# IMPROVEMENT PERMIT for a RESIDENTIAL ON-SITE WASTEWATER TREATMENT & DISPOSAL SYSTEM

Permit #: 30001083 GWS File #: 6642B Tax Parcel #: 019-243-14

Re: **Improvement Permit Application for Lot #11 Pavilion Estates Drive**
**For The Pavilion Subdivision, Parcel #023-201-02 PO,**
**MCHD File # Pending** 6642B
**Mecklenburg County, North Carolina**

# SEPTIC SYSTEM DESIGN REVIEW WORKSHEET

**Design Specifications for Lot 11 The Pavilion Subdivision, Huntersville North Carolina**

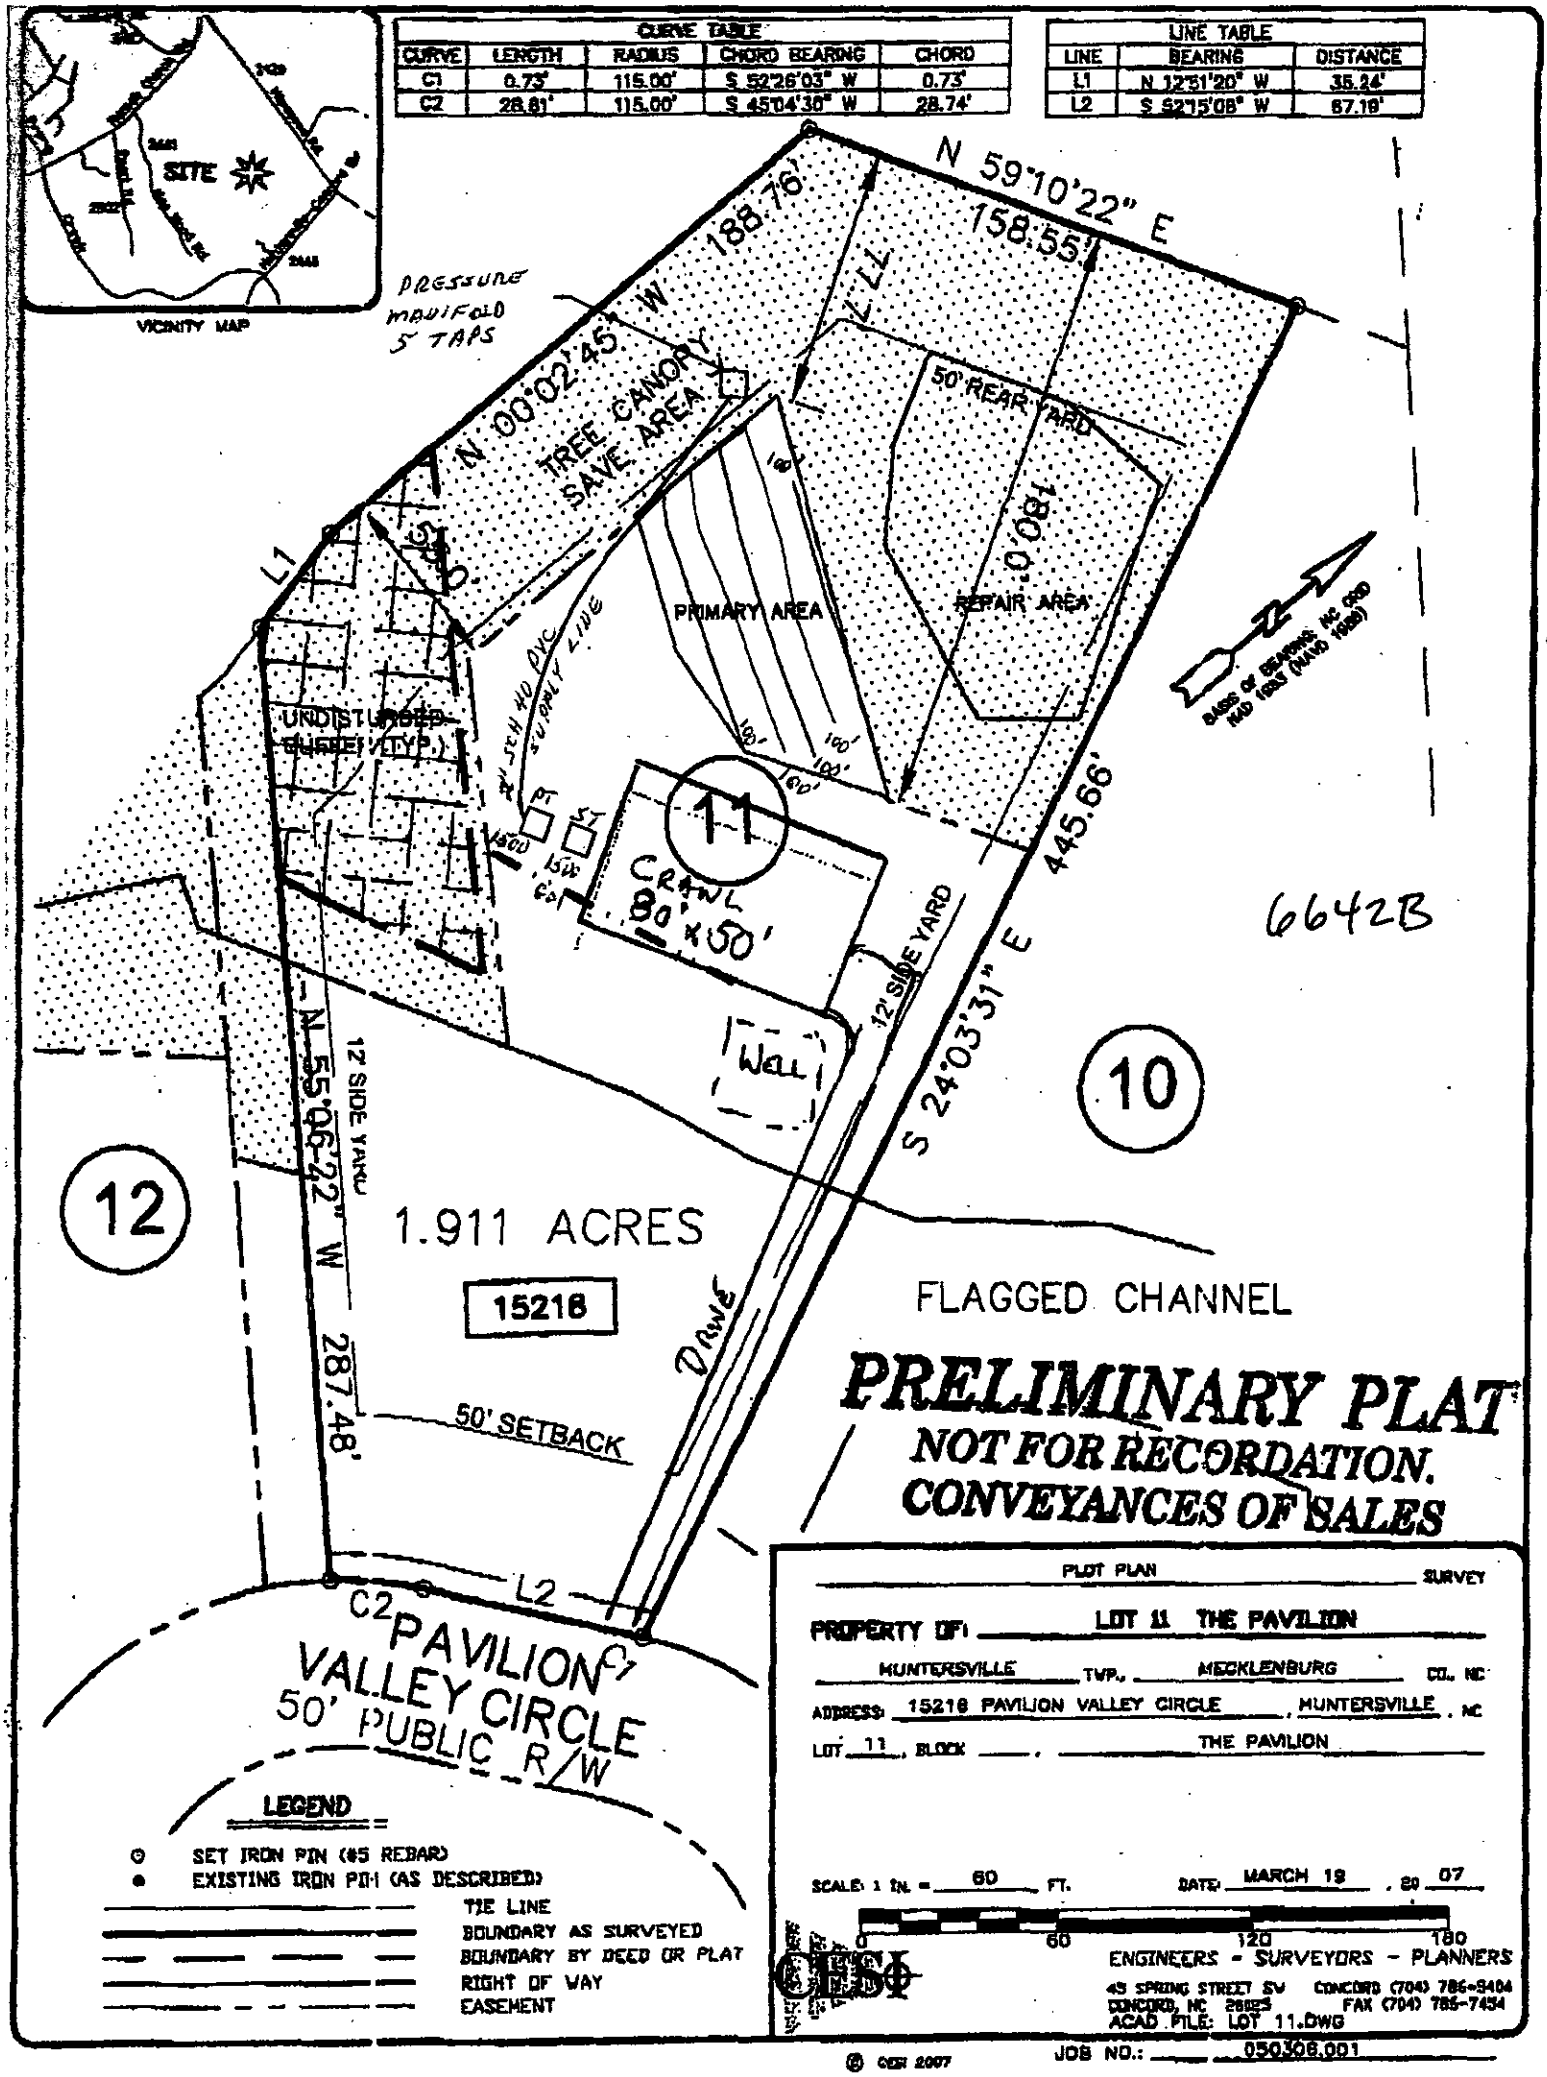
*PENDING APPROVAL 4-17-07 (CT)

| Number and Length of Lines | 5 @ 100ft ~~and one line at 40ft~~ |
| Total foot of Primary System | Need 480 provided 500ft ✓ |
